# Board of Adjustment Staff Report

Subject: Administrative Permit Case Number WADMIN17-0003  
Applicant: Powning Family Trust  
**Agenda Item Number: 9B**  
Summary: To allow construction of a 4,000 square foot metal building that is larger than the 1,310 square foot main dwelling  
**Recommendation: Approval with Conditions**  
Prepared by: Chad Giesinger, Senior Planner  
Washoe County Community Services Department  
Planning and Development Division  
Phone: 775.328.3626  
E-Mail: cgiesinger@washoecounty.us

**Administrative Permit Case Number WADMIN17-0003 (Powning DAS)** – For possible action, hearing, and discussion to approve an Administrative Permit to allow the construction of a detached accessory structure that is larger than the main dwelling on the parcel. The proposed detached accessory structure is a 4,000 square foot pre-fabricated metal building and the existing main dwelling is a 1,310 square foot single story structure.

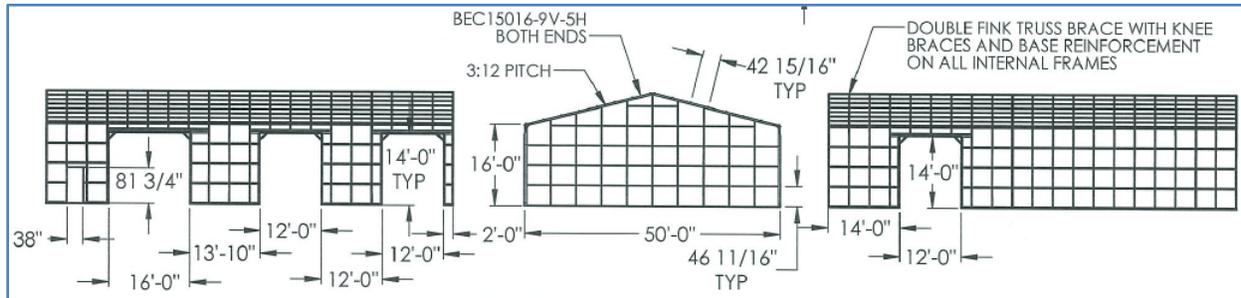
The applicant is seeking to construct a detached metal building (i.e. a detached accessory structure, or DAS) behind the existing main dwelling approximately in the center of the 1.61 acre property at 265 Bridge St. The building is proposed to have electrical connection, but no plumbing fixtures (i.e. water or sewer). The detached accessory structure is proposed to be 50 feet by 80 feet (4,000 square-feet) in size and approximately 20 feet high at its peak. The dwelling on the parcel is 1,310 square-feet in size. Per Washoe County Code (WCC) section 110.306.10(d), a proposal to construct an accessory structure that is larger than the main dwelling on the parcel requires the approval of an Administrative Permit.

Large detached accessory structures are relatively common in the vicinity of the subject site, which is located just north of old downtown Verdi. Several surrounding properties either have large barns or similar metal buildings. The applicant is proposing to replace several existing old structures and a parked trailer on the property with the new metal building. The intended use of the building is for storage and to create a space for family hobbies.

The topography of the subject site and most of the surrounding area is essentially flat. Visual impacts should be minimal as there are no significant views from adjacent properties in jeopardy of being blocked. The Verdi Elementary school is located directly across the street. The proposed location of the building is in the center of the property and is nearly 75 feet from the nearest building on adjoining property. The subject property has a regulatory zone of Medium Density Suburban (MDS) which requires structure setbacks of 20 feet in the front and rear yards, and 8 feet in the side yards. The proposed location of the building satisfies the required structure setbacks. The applicant is proposing to paint the building with neutral colors and plant trees along the west side of the building to soften structure sides. The sides of the building will be light gray with a charcoal roof.

It is the opinion of staff that there are few, if any, negative impacts associated with the construction of the proposed detached accessory structure. Standard conditions of approval have been included to require that the structure be painted so as not to reflect sunlight and glare. Staff believes that the requisite findings can be made for approval of the Administrative Permit request. A drawing of the proposed structure and its dimensions follows:

- d. Trees shall be planted, at a minimum, along the western wall of the building to mitigate visual impacts.
- e. There shall be complete screening of roof mounted HVAC equipment, if any.

- f. The exterior color of the metal building shall be painted a muted neutral color and in no event produce reflecting light and glare.
- g. A note shall be placed on all construction drawings and grading plans stating:
